ELECTRIC POWER
RESEARCH INSTITUTE

PDI UT-8 Revision F and PDI UT-10 Revision C

Review of Changes

ENCLOSURE 5

Table A
(Ranges of Applicability)

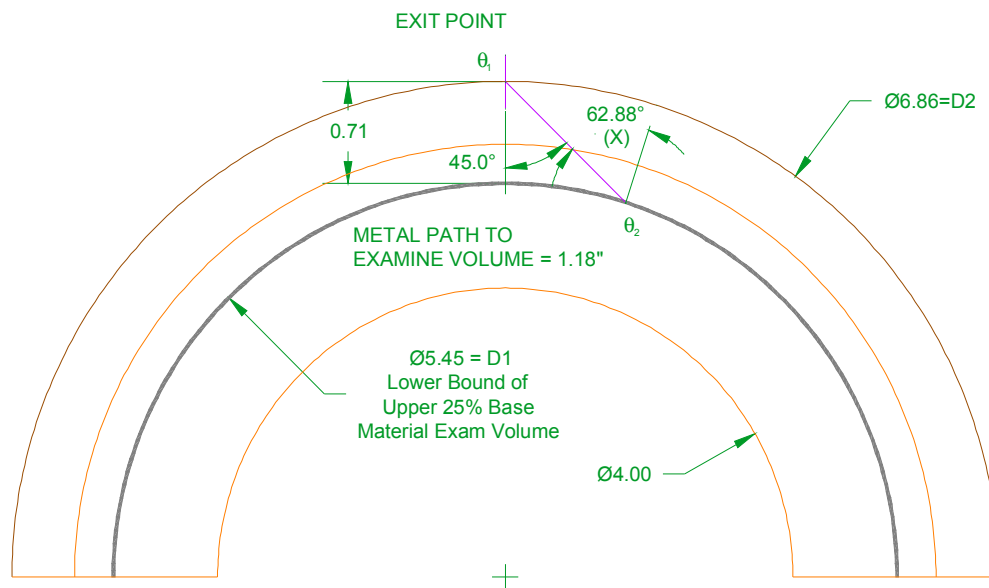
Deleted: Nominal Pipe

- The words “Nominal Pipe” replaced with “Component” and Pre-Overlay added
 - This was done for clarification purposes
